INN *at the* MARKET

Response (In Red) to application questions on 11/25/24:

2 IATM LOBBY FLOOR PLAN  
A1.2B 3/16" = 1'-0"

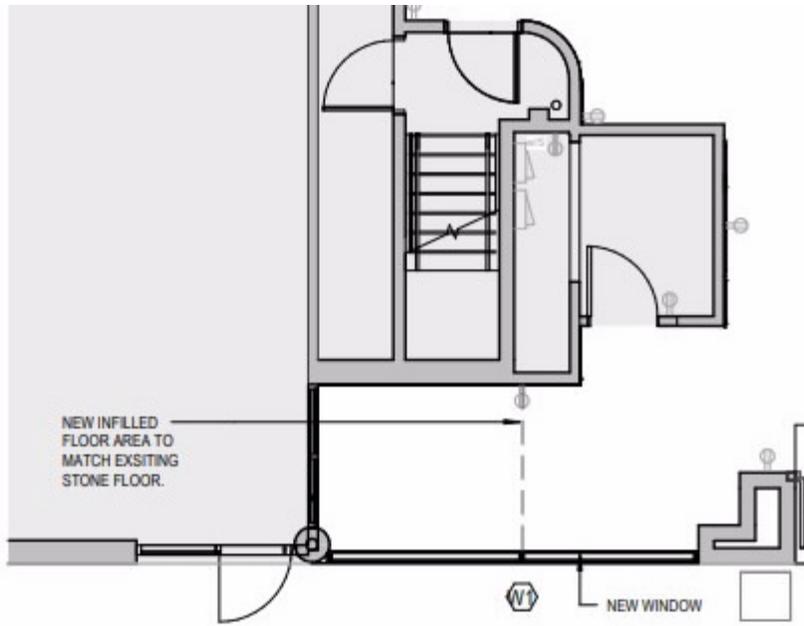
- 2) Provide an elevation drawing showing the existing, to more clearly show what is changing. Revise elevation drawings to show a greater portion of the building. It's difficult to fully understand the proposed design with the limited elevations provided. Note the location of the new door on the "after" floor plan drawing. **There is no new door. The same door to the north is there in both drawings.** Explain the change to the wall between the work area and the adjacent space (

Provide specifications for the new door and windows. **There is no new door.**

1 LEVEL 2 - ELEVATION - COURTYARD BUILDING  
A4.2 1/8" = 1'-0"

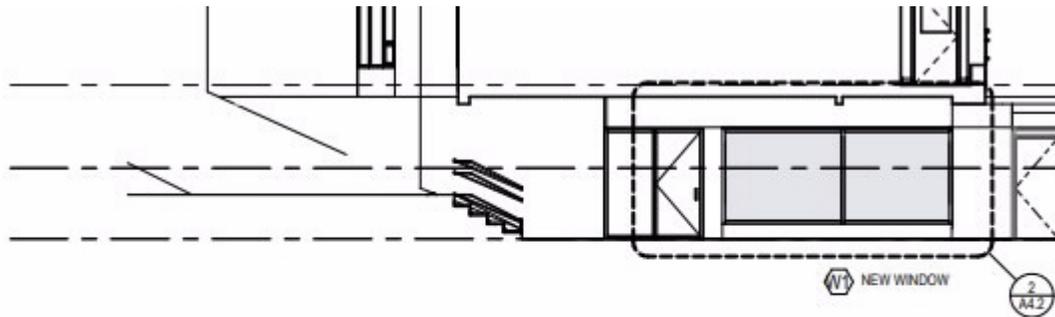
How will the window adhere to the round column? It will be screwed to the column through the aluminum window frame (hidden fasteners) in the same way the existing window does on the other side.

What type of material is the black metal frame? The metal frame is aluminum.

2 LEVEL 2 - ELEVATION - COURTYARD ENTRY  
A4.2 3/8" = 1'-0"

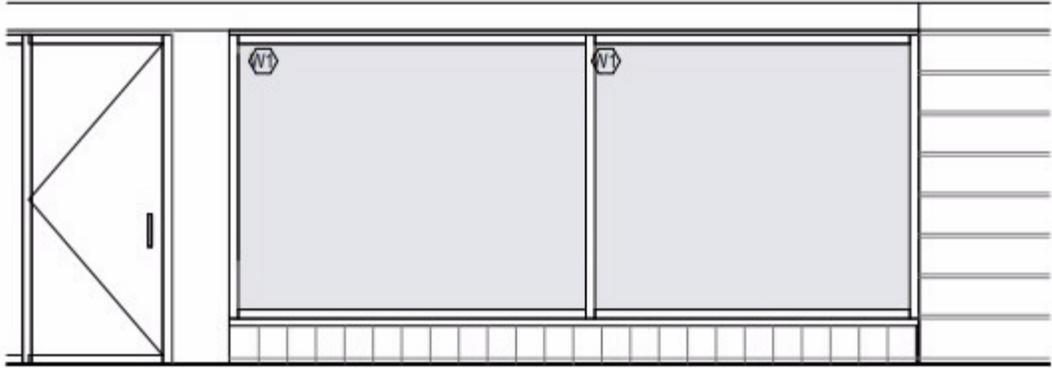
What is this area below the window made of? . There is a concrete curb under the tile. This will be extended under the new window to match. The metal flashing is aluminum. Same black aluminum frame.
